Metropolitan Coal Mine

Longwalls 317 & 318 Modification

Submissions Report

Table 4-1
Longwall Geometry Comparison of Underground Mines in the Southern Coalfield

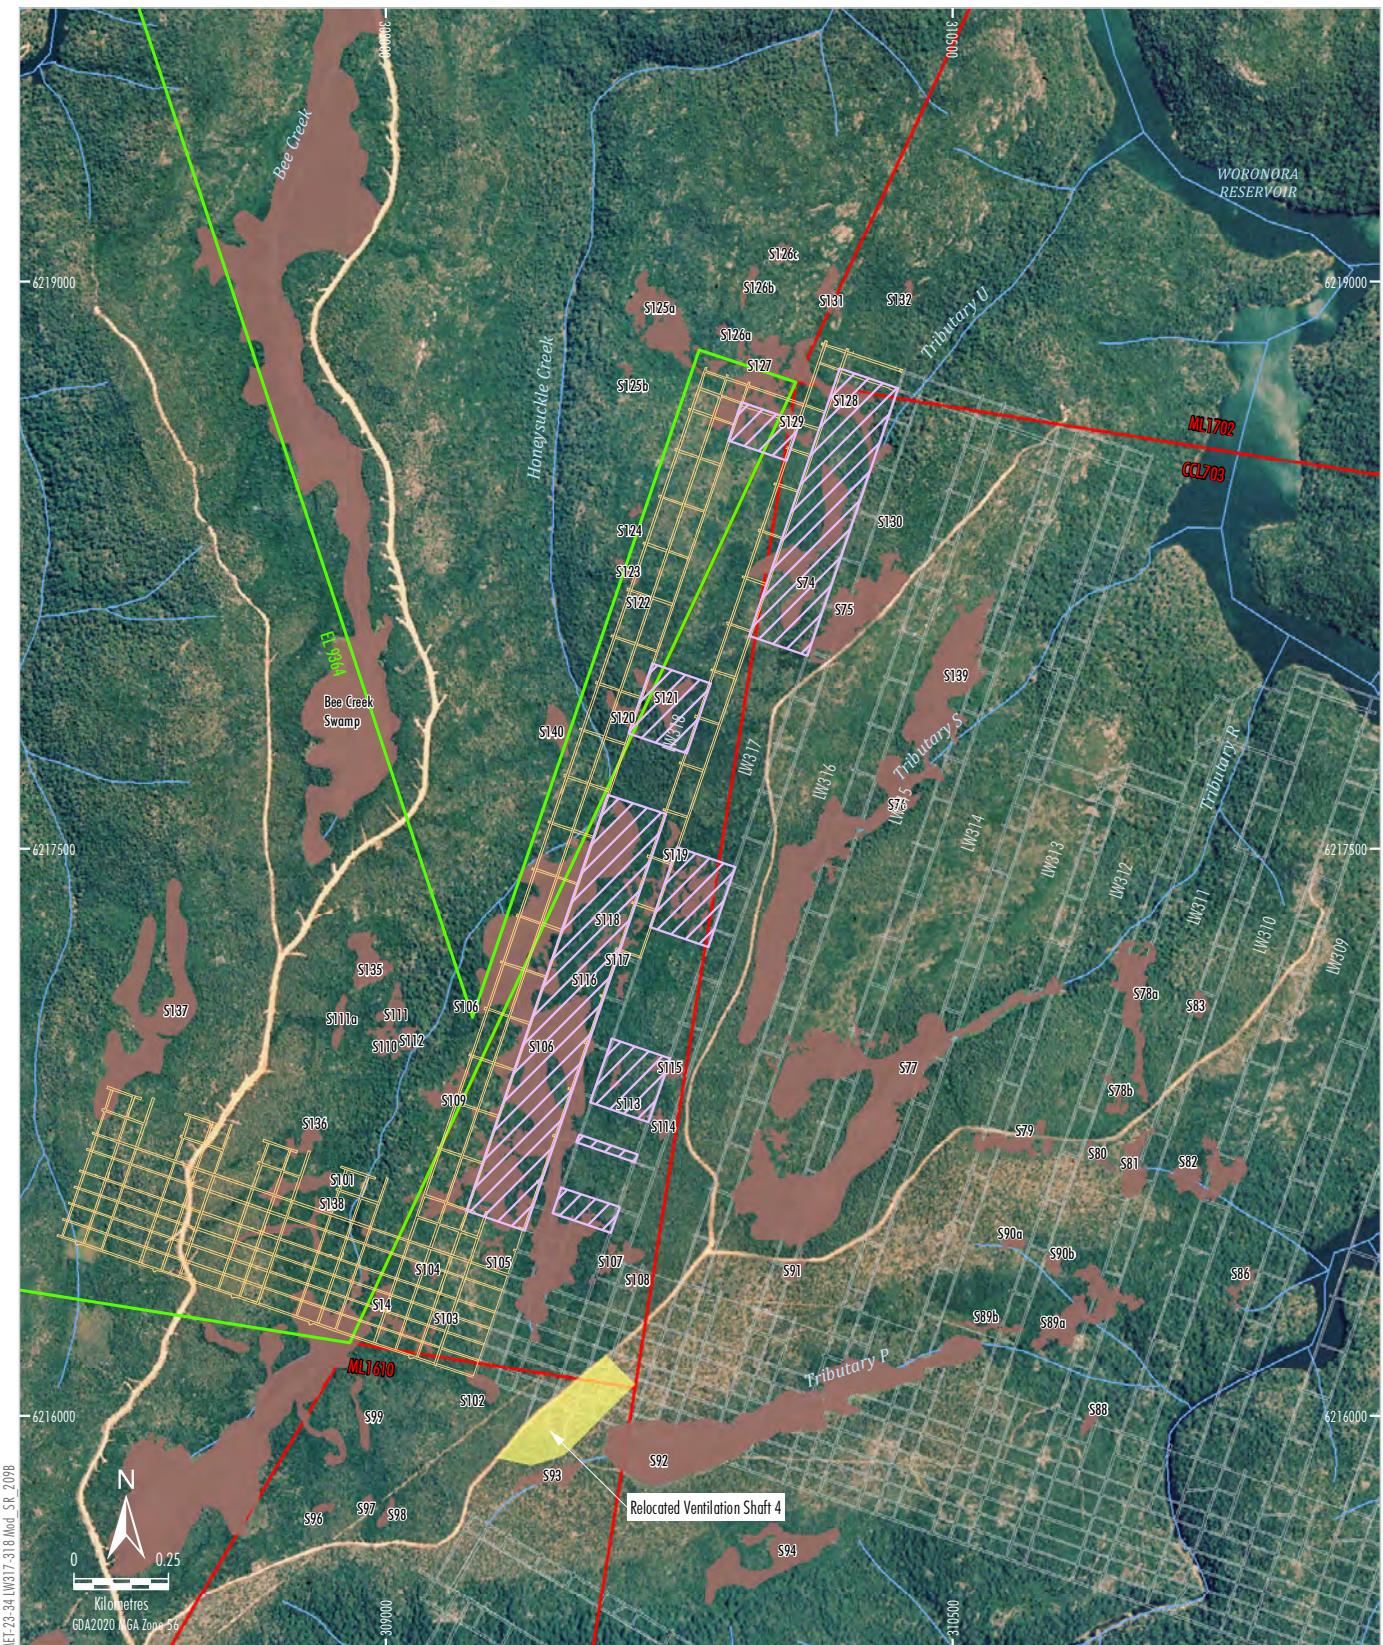
It is noted that panels under the Woronora Reservoir have reduced longwall dimensions (133m longwall widths and 70m wide pillar widths) to protect the dam from subsidence impacts. The BDAR should equally consider these options to be relevant to avoid serious impacts to biodiversity (and water resources) in a sensitive water catchment area. Optimally, this would include a longwall layout which avoids undermining threatened swamps and other significant features including streams that provide threatened species habitat.

As the Bulli Seam is remarkably consistent in thickness, the main variable is the W/H ratio. The W/H ratio at Metropolitan Coal Mine during extraction beneath the Woronora Reservoir was approximately 0.31 to 0.35 (Table 4-1), significantly more conservative than other mines in the southern coal fields. The design for Longwalls 317 and 318 is at 0.30 to 0.32 W/H ratio. Longwalls 317 and 318 will use what is arguably a more conservative geometry to pass beneath the swamps than was utilised for mining beneath the Woronora Reservoir. (Table 4-1).

In comparison to other underground coal mines in the Southern Coalfield, Metropolitan Coal has significantly more conservative longwall geometry (Table 4-1).

Figure 4-3

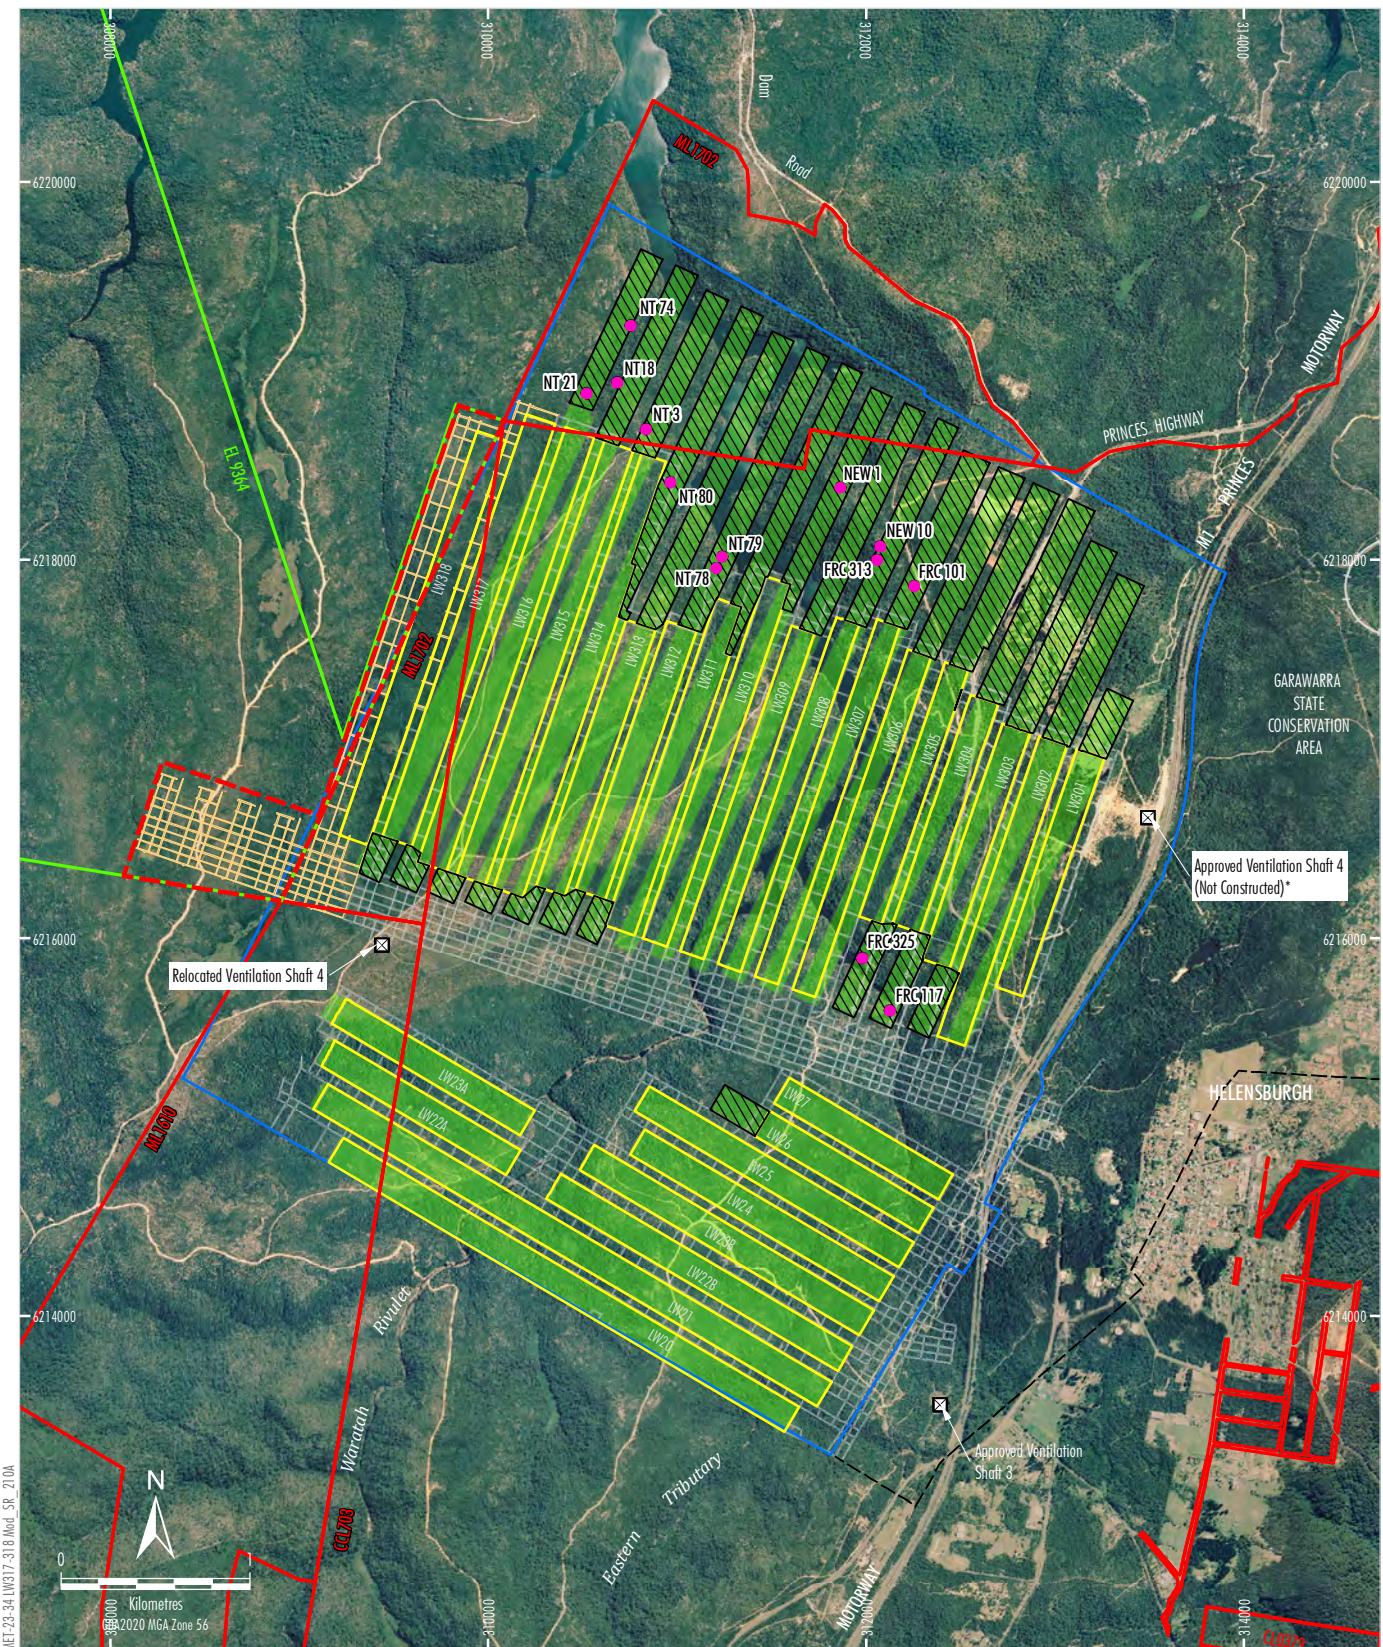
The Modification Report and ACHAR state that sections of the approved mine will be relinquished (Figure ES-3 Modification Report). However, it is not clear from the ACHAR whether this relinquishment is the result of mine operational changes and/or active consideration of conservation of ACH and ecology. If, as Section 8.2 of the ACHAR states, these relinquished areas will act as conservation for ACH, Heritage NSW recommends that a thorough archaeological and cultural assessment are undertaken in these areas (if not done) so that consideration can be given to those sites that will be conserved and their significance to justify any potential offsetting of harm to ACH.

There are 13 known Aboriginal cultural heritage sites located within the proposed relinquishment areas which would experience a reduction or complete avoidance of subsidence impacts approved for the Metropolitan Coal Mine (Figure 4-3).

Figure 4-4

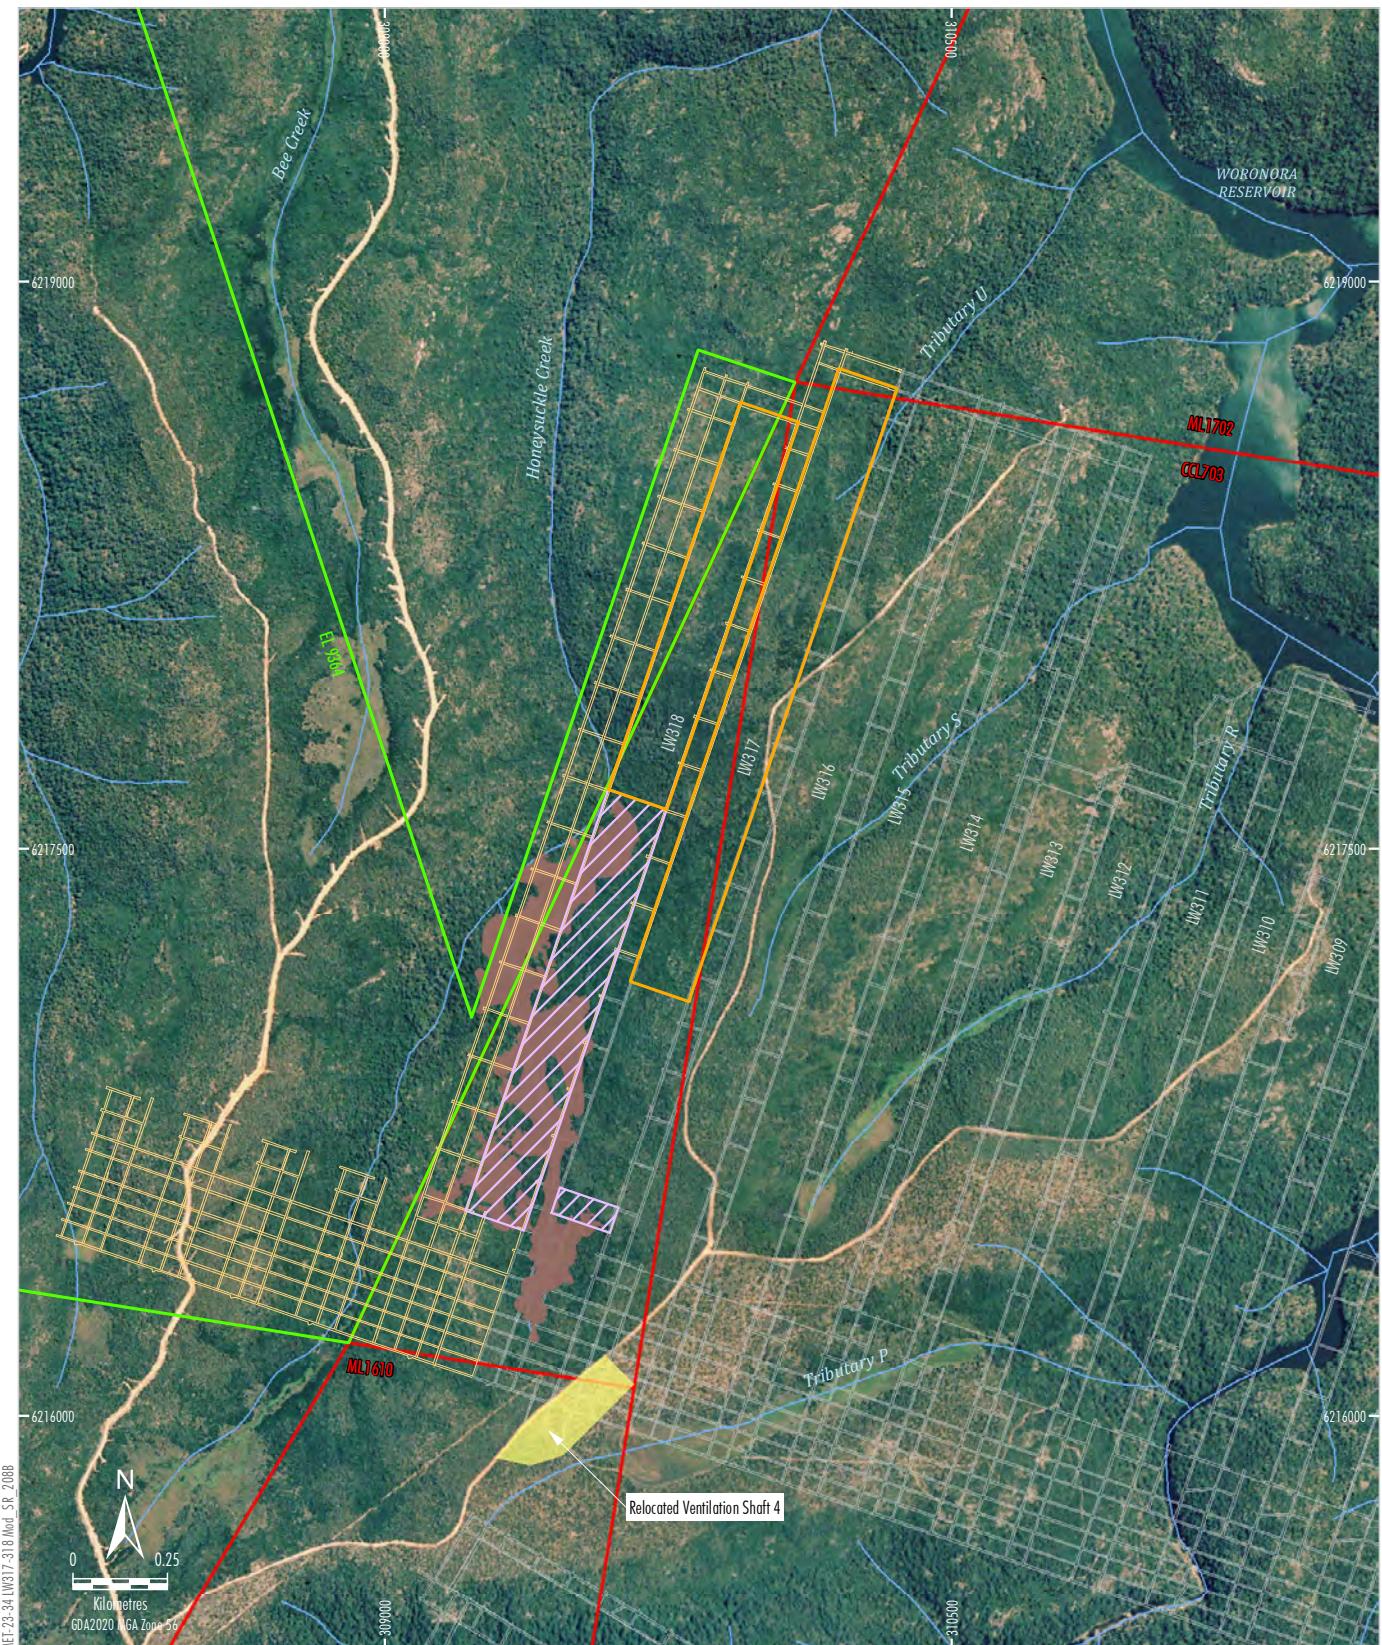
Complete avoidance of mining beneath Swamp S106 is the only effective protection of the swamp, given the size and sensitivity of Swamp S106, and the difficulty of reversing potential impacts. As such, WaterNSW recommends redesign of mine layout to avoid impact prior to approval of this proposed Modification. Relying on an Adaptive Management Plan (AMP) would not provide adequate safeguards for such a significant and vulnerable swamp, especially when impacts might materialise after it is too late to mitigate them.

If the mine layout incorporated the complete avoidance of mining beneath Swamp 106, the secondary extraction area would reduce from approximately 36 ha to 17 ha resulting in less than half of the proposed Modification layout (Figure 4-4).
